MFN 06-094

Docket No. 52-010

**Subject: Revised Response - GE Response to Results of NRC Acceptance Review for ESBWR Design Certification Application – Item 2**

### **Revised Response - GE Response to Results of NRC Acceptance Review for ESBWR Design Certification Application – Item 2**

Figure 3-1. Feedwater Line Model for FWL Break Analysis

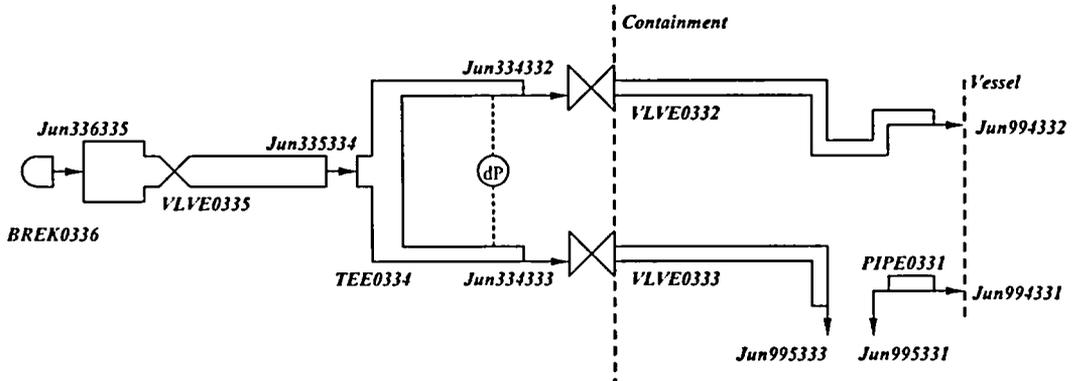
Provide design information to document that the largest possible feedwater line break location and area was considered. State the break area on both sides of the break. 10 CFR 50.46 requires that a spectrum of break sizes and locations be analyzed to demonstrate that the limiting break has been identified.

Figure 3-1 shows the schematic of the entire feedwater line model. The model encompasses the feedwater lines from the FW heaters to the RPV. Figure 3-2 depicts a single flow path that represents parallel trains of FW heaters and FW pumps in the Turbine Building. Elevations are conservatively assumed so that the inventory can be flashed into the containment through the postulated break location.
